Docket Number:	23-AFC-03
Project Title:	Black Rock Geothermal Project (BRGP)
TN #:	253937
Document Title:	Black Rock Geothermal Project CURE Data Response Set 2 (Responses to Data Requests 100 to 242)
Description:	N/A
Filer:	Lindsey Xayachack
Organization:	Jacobs
Submitter Role:	Applicant Consultant
Submission Date:	1/17/2024 4:43:29 PM
Docketed Date:	1/17/2024

CURE Data Response Set 2 (Responses to Data Requests 100 to 242)

**Black Rock Geothermal Project
(23-AFC-03)
January 17, 2024**

Figure DR 177
Agricultural Return Flows
Black Rock Geothermal Project
Imperial County, California

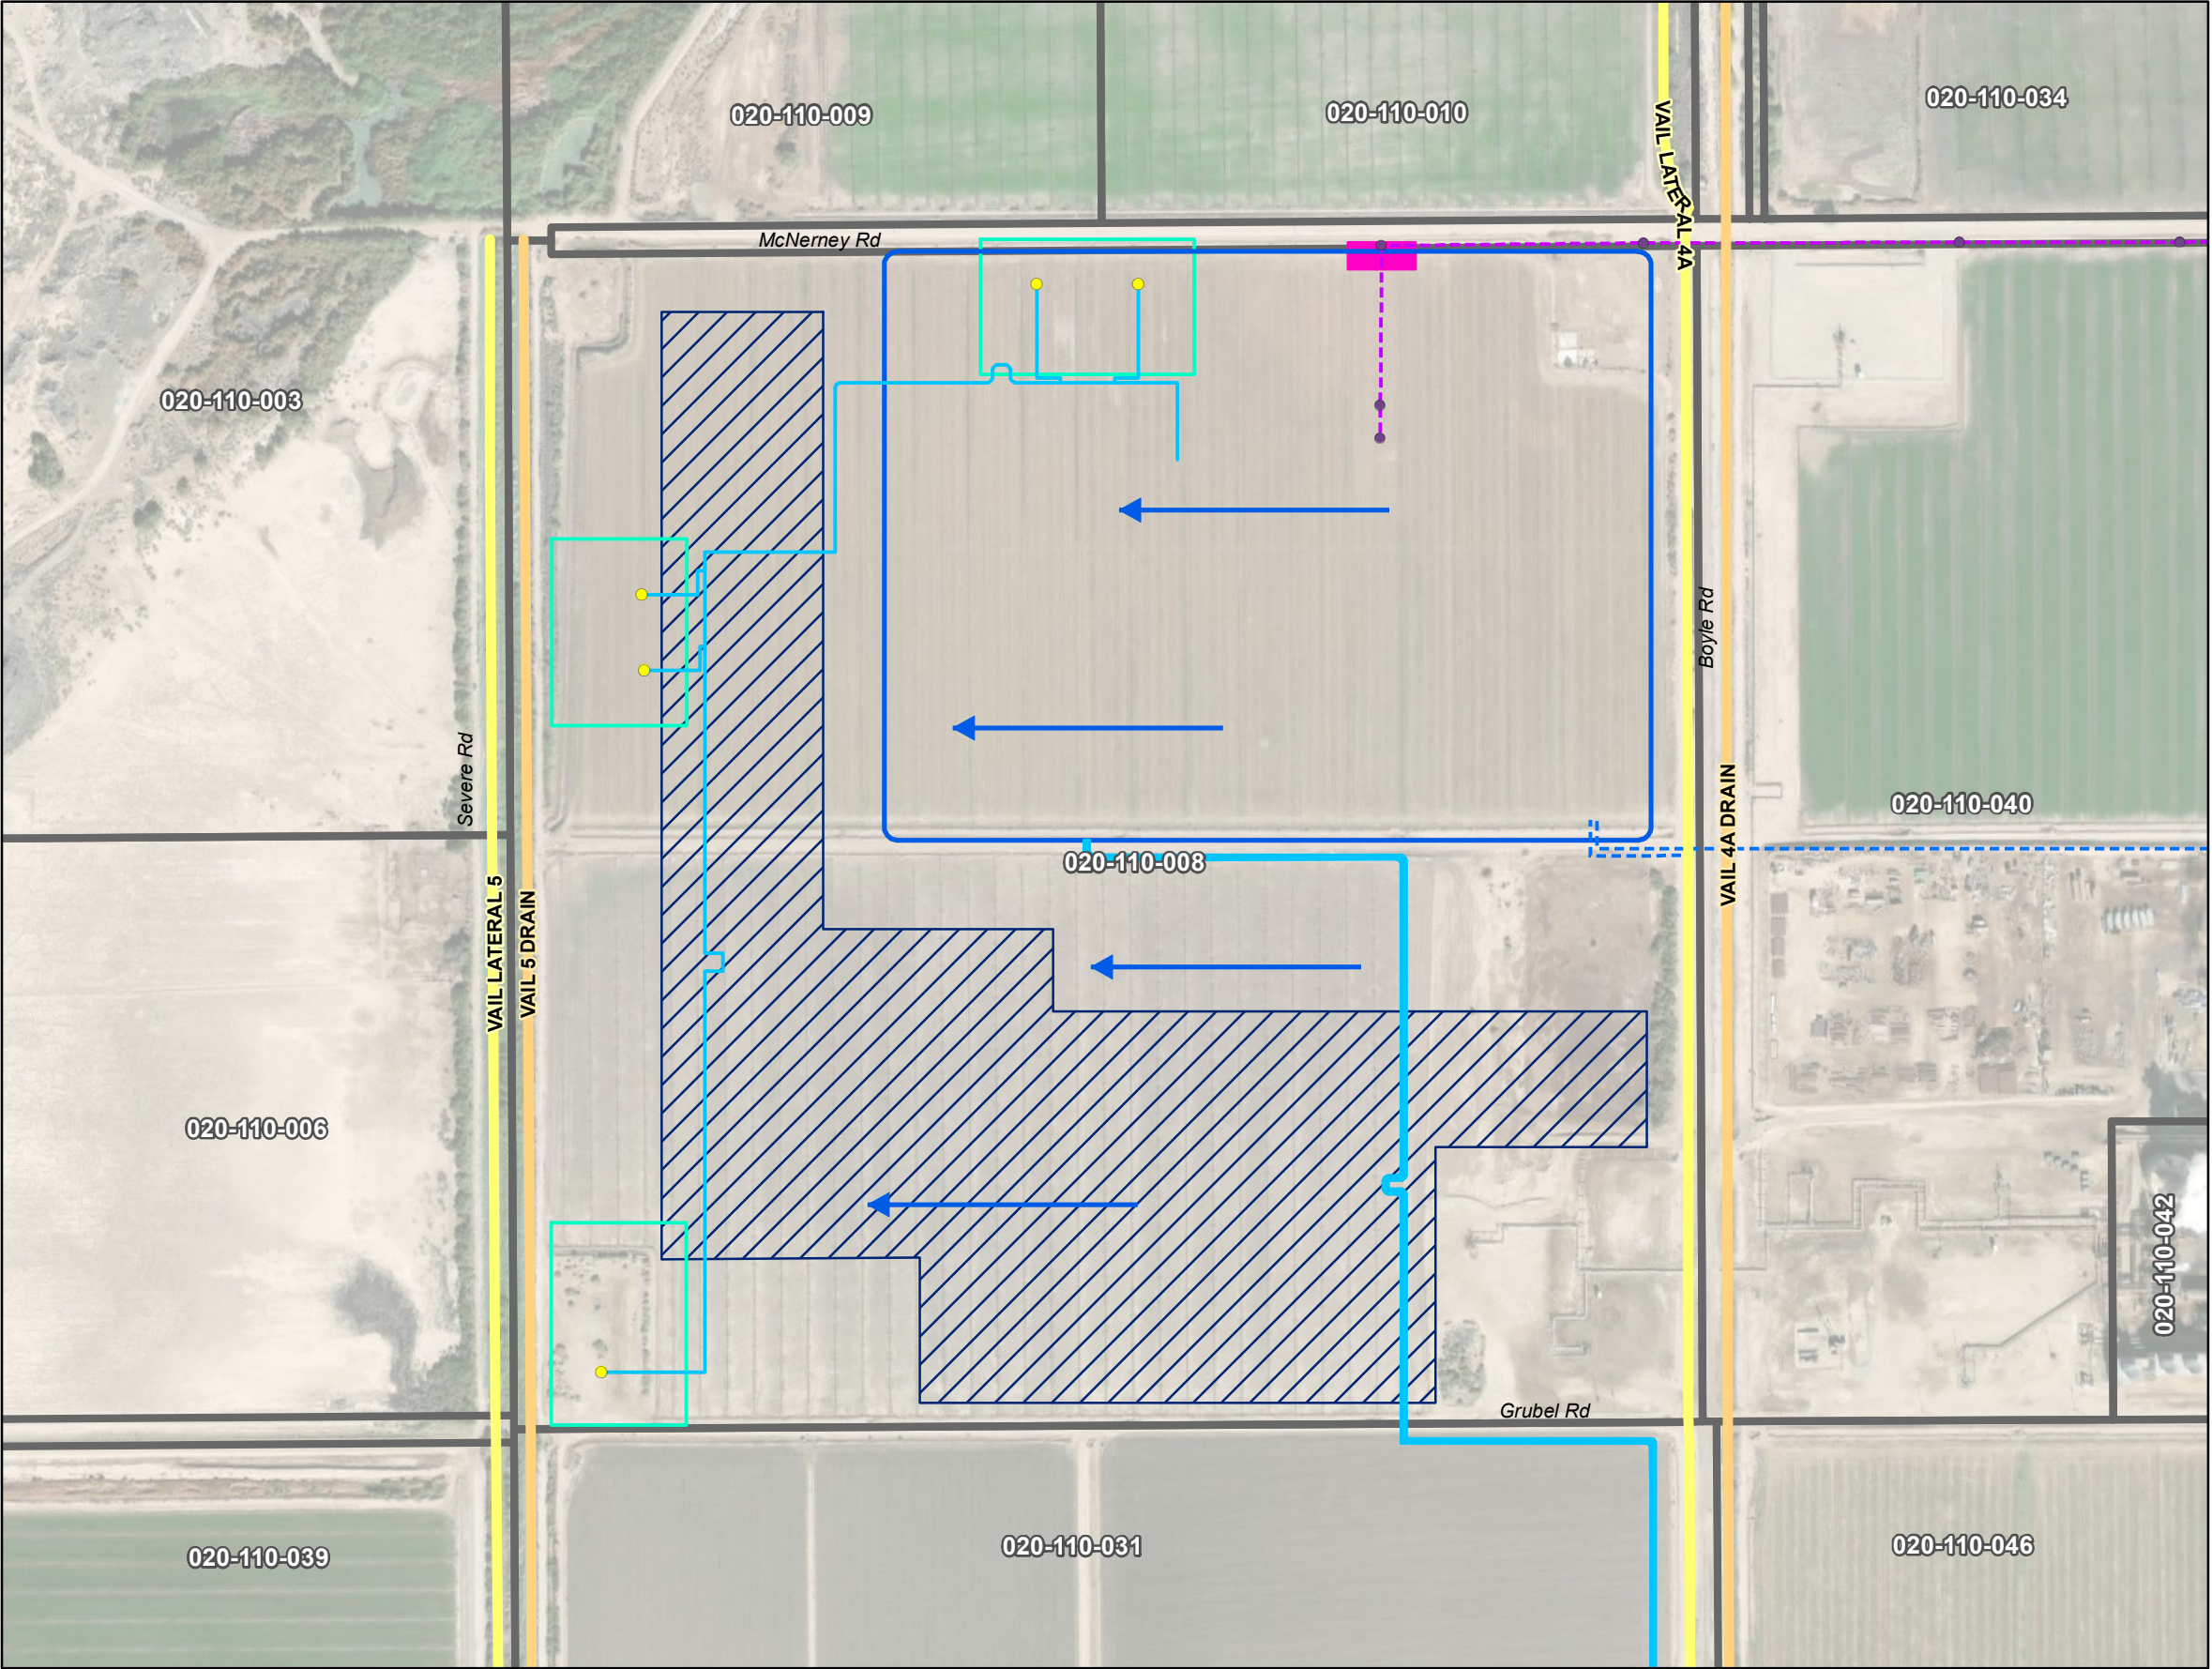
177. *Provide a map that identifies the path of agricultural return flows (irrigation runoff) from the agricultural fields that would be impacted by the Project.*

Response: Figure DR 177 identifies the Project site and the existing agricultural runoff for APN 020-110-008, which currently drains to the Vail 5 Drain.
